TOWN OF SHREWSBURY

July 19, 2019

Re: Site Plan Approval and Special Permit
180-222 Hartford Turnpike
Edgemere Crossing at Flint Pond

ATTACHMENT A

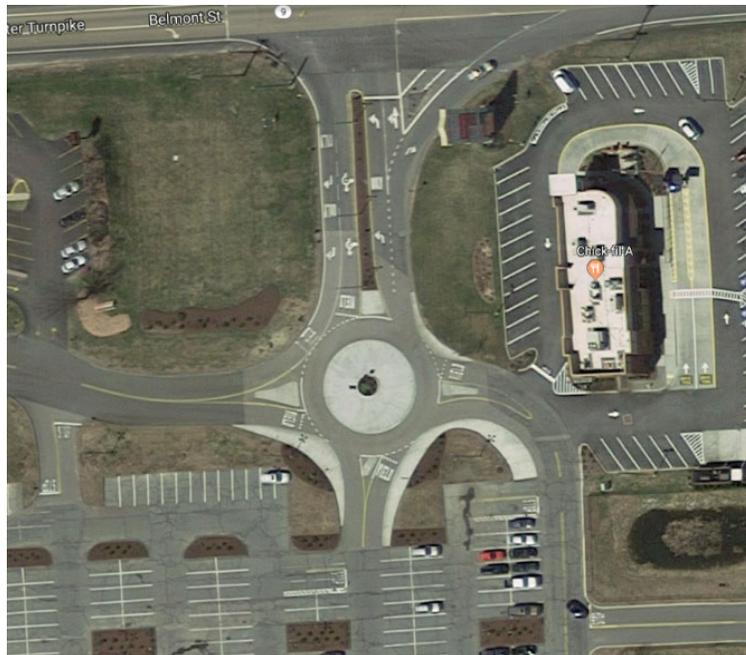
- d. The Planning Department, Highway and Engineering Divisions, and Police Department recommend that serious consideration be given by the applicant to replacing the two proposed internal four-way intersection on the western side with roundabouts to address the Town's concerns with internal traffic flow in these locations. These concerns include but are not limited to: left turns out of the bank pad, left turns out of the retail pad, left turns into the upper parking lot as a driver enters from Route 20, cars encroaching on crosswalks when stop signs are off-set behind crosswalks, and the challenge of creating four-way stops in lieu of the proposed two and three-way stops. (See Attachment A for regional roundabout examples)
